**WELDING
INDUSTRIES
AUSTRALIA**

SERVICE BULLETIN

REMOVAL OF ALPHA-NUMERIC DISPLAY FROM MILLER BIG BLUE 800X DUO AIR PAK 907763

EFFECTIVE WITH SERIAL NUMBER NE140303R

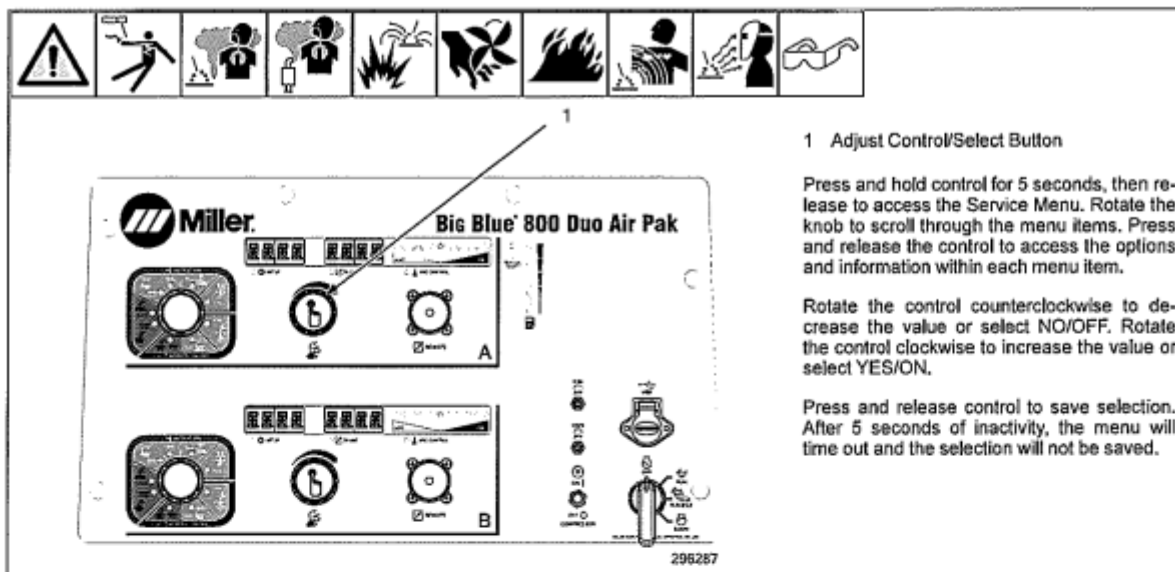
After careful consideration, ITW (Welding Products Group) has made the business decision to delete the LCD Alpha-Numeric Engine Display (the "Murphy" display") from new production units of Miller Big Blue 800X Duo Air Pak machines with stock number 907763. This change was necessary due to supply and support issues with the vendor who builds the display.

Engineering evaluation determined that installation of individual gauges in place of the Alpha Numeric Display is not practical. Accordingly, and effective with serial number NE140303R and later units, all parameters previously accessed through the Alpha-Numeric Display are available to the operator through the Service Menu function on the upper control board, PC1.

Instructions for accessing the Service Menu and a list of selectable and view-only parameters are provided in Operator's Manual 282374 Revision S (September 2024) and in Technical Manual 282374 Revision F (December 2024). These instructions are included with this memo for reference.
